**RE: ADDENDUM TO SAMPLING AND ANALYSIS WORK PLAN  
WOODWORTH LAKEVIEW FACILITY REMEDIATION  
2800 104<sup>TH</sup> STREET COURT SOUTH, LAKEWOOD, WASHINGTON  
FARALLON PN: 188-002  
VCP IDENTIFICATION NO: SW1012**

**Re: Review of September 25, 2017 "Sampling and Analysis Work Plan, Lakeview Facility, 2800 104<sup>th</sup> Street Court South, Lakewood, Washington, VCP Identification No. SW1012"**

**FIGURE 6**

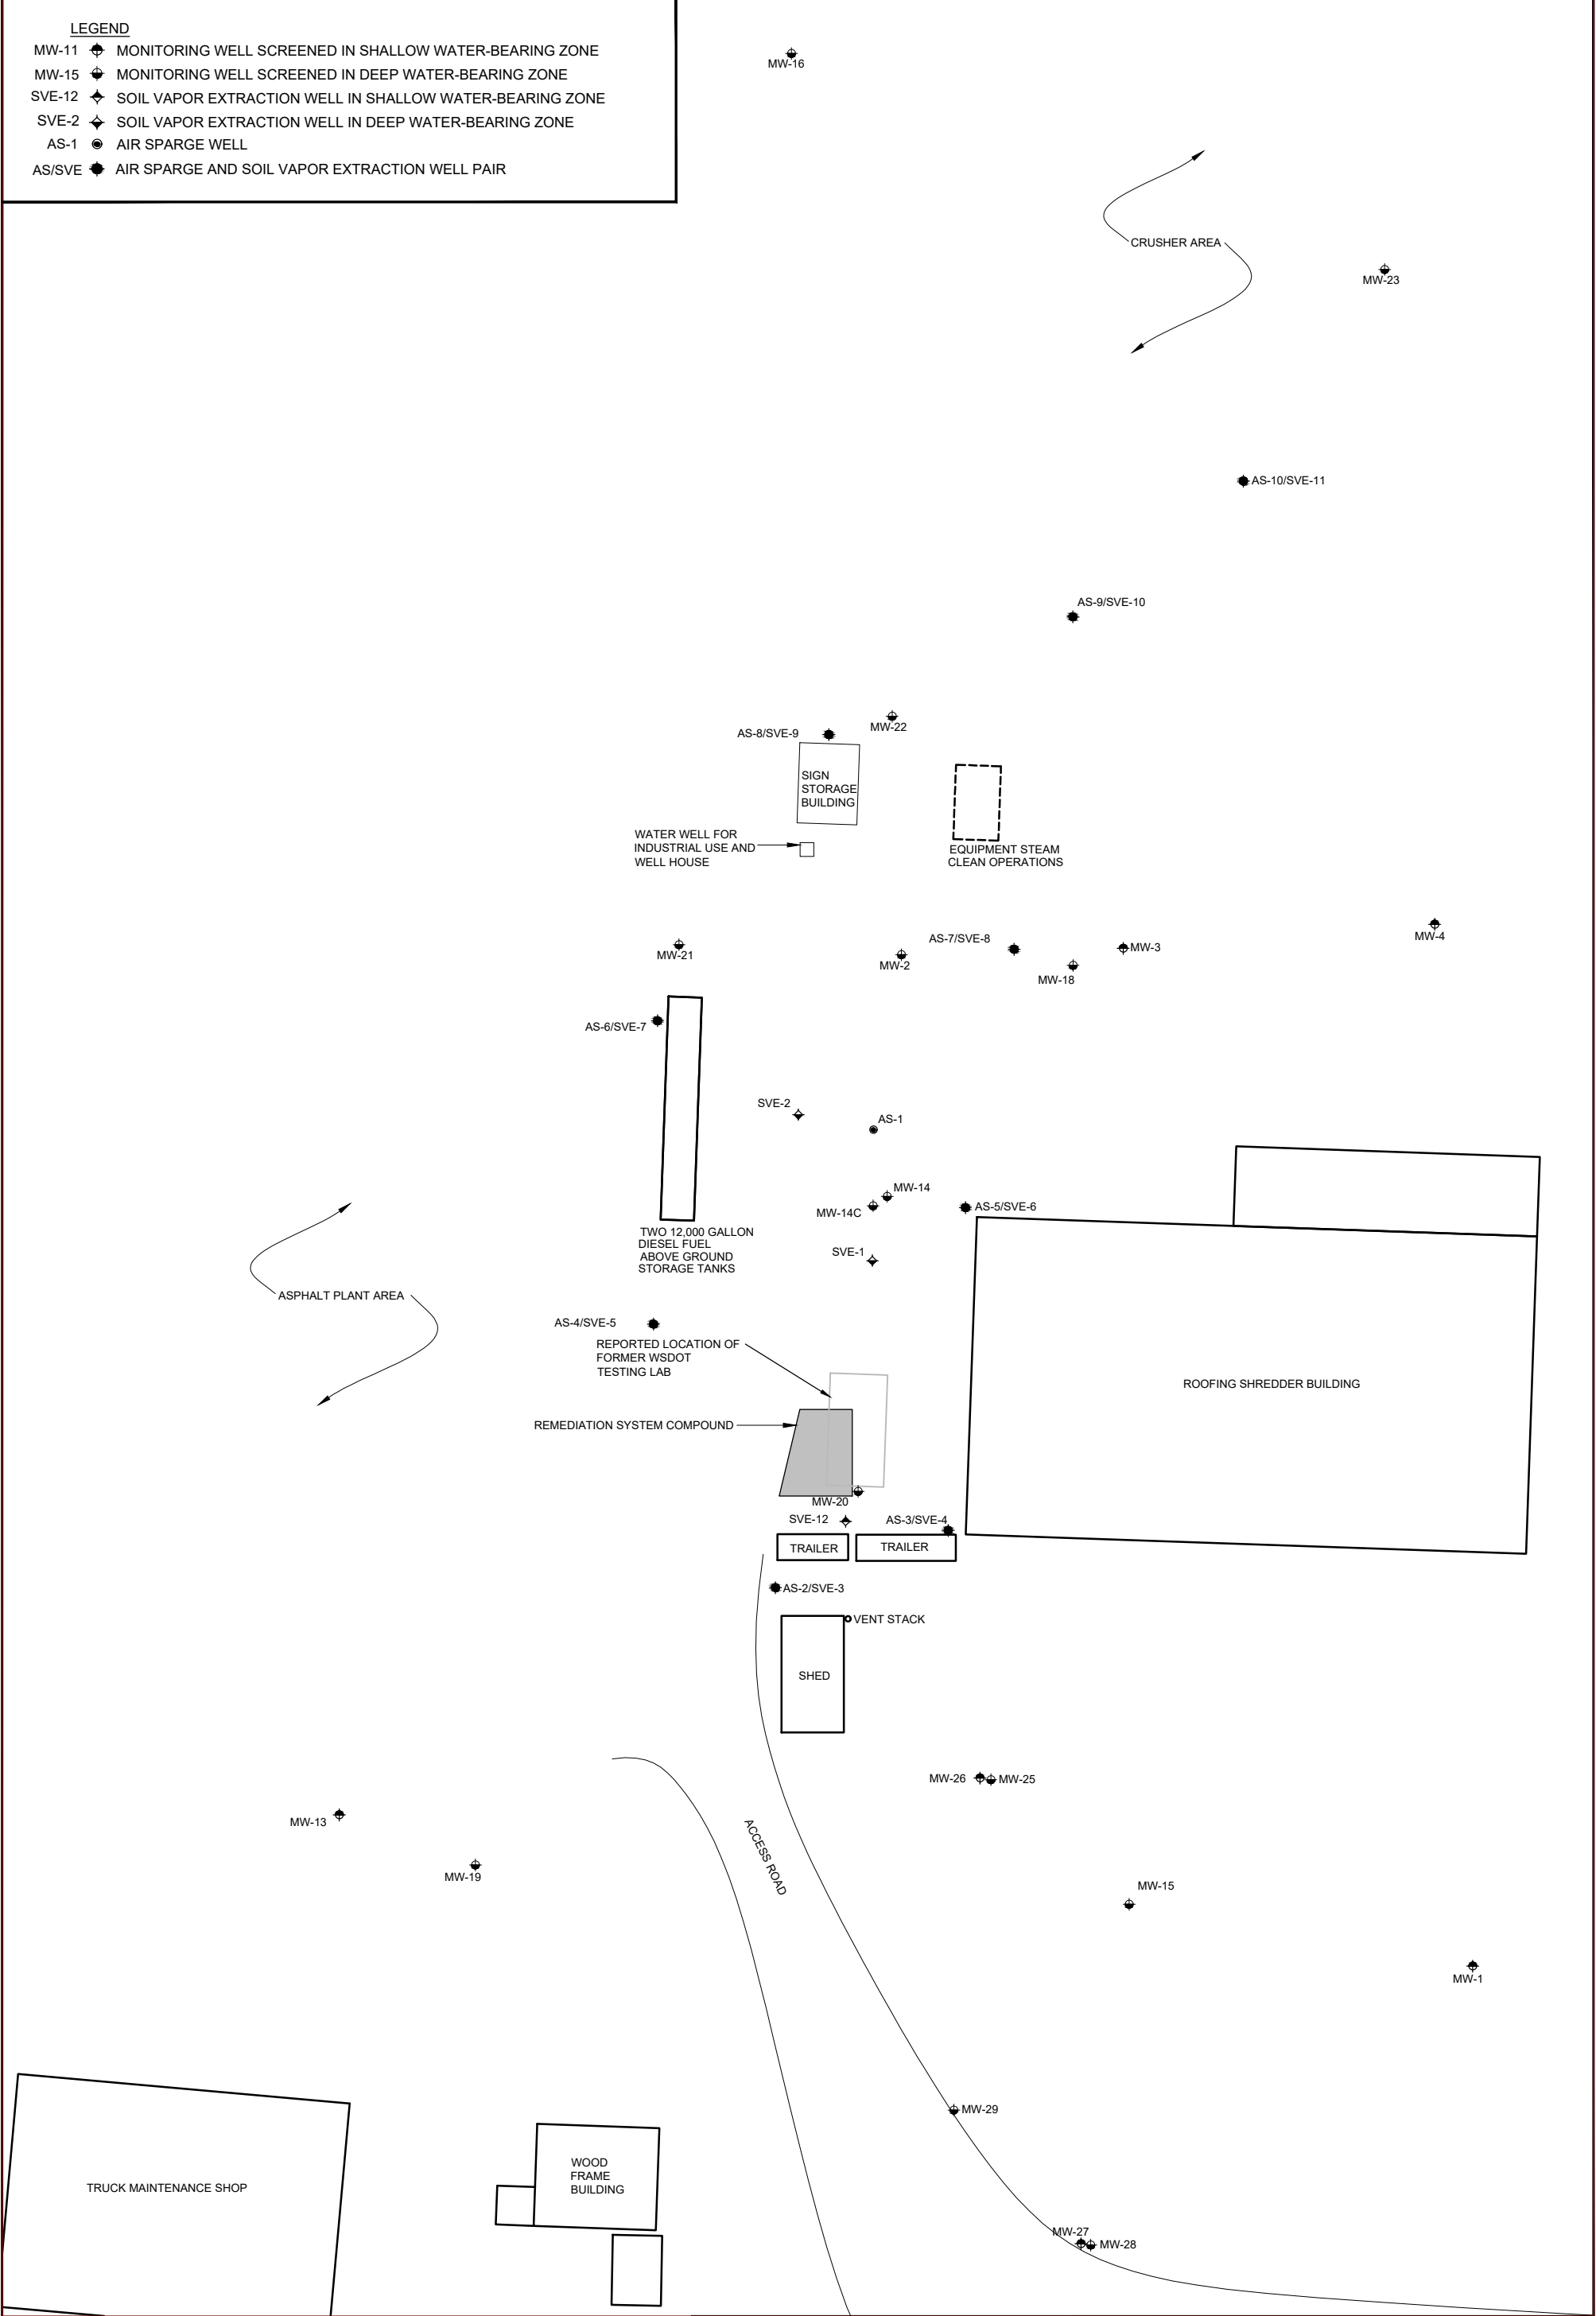
In Ecology's letter to Farallon, dated May 25, 2017, Ecology requested additional soil testing of polychlorinated biphenyls (PCBs) and polycyclic aromatic hydrocarbons (PAHs) in the areas of the Washington State Department of Transportation (WSDOT) asphalt-testing laboratory area, and adjacent features indicated as "asphalt plant", "tar tank", and "hot mix plant areas."

- Advancing three borings to 10 feet bgs in the areas identified as the asphalt plant, tar tank, and hot mix plant (Figure 6). A minimum of one soil sample collected from each of these borings will be analyzed for DRO, ORO, PCBs, and carcinogenic PAHs.

- Advancing five borings in the area proximate to the reported former location of the Washington State Department of Transportation testing laboratory. A minimum of one soil sample collected from each of these borings will be analyzed for volatile organic compounds (VOCs), DRO, and ORO (Figure 6). Two soil samples with highest concentrations of DRO and ORO from these borings be analyzed for PCBs and carcinogenic PAHs.
